Re: Permit #: PRRES20181851
1531 SW Blackstone Pl
Lee's Summit, MO 64082

Apex Engineers, Inc. has been asked to address comments from the city rough-in inspection for the house at the address above.

Provide engineers report on cut LVL in master bedroom.

| Location = | North End |

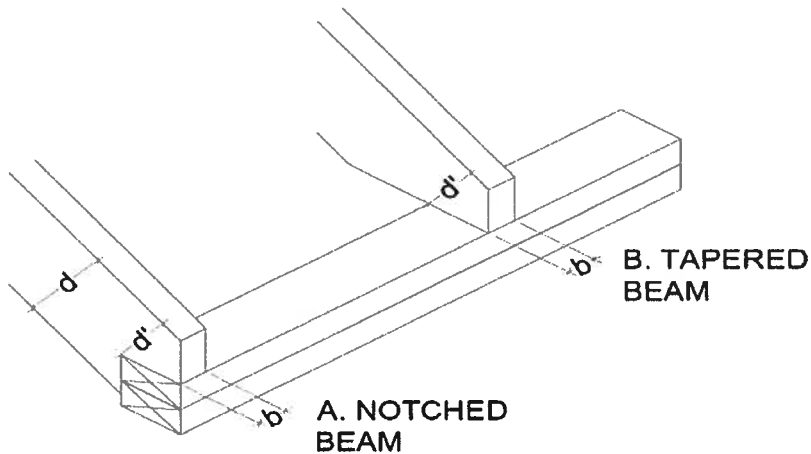
- The (2) 1 3/4"x18" LVL has a tapered notch at each end. There is 9" of remaining member depth at the notch, measured at the bearing wall at each end of the beam. After computations, the (2) 1 3/4"x18" LVL adequately supports the design loads.

| Pass or Fail | Pass |
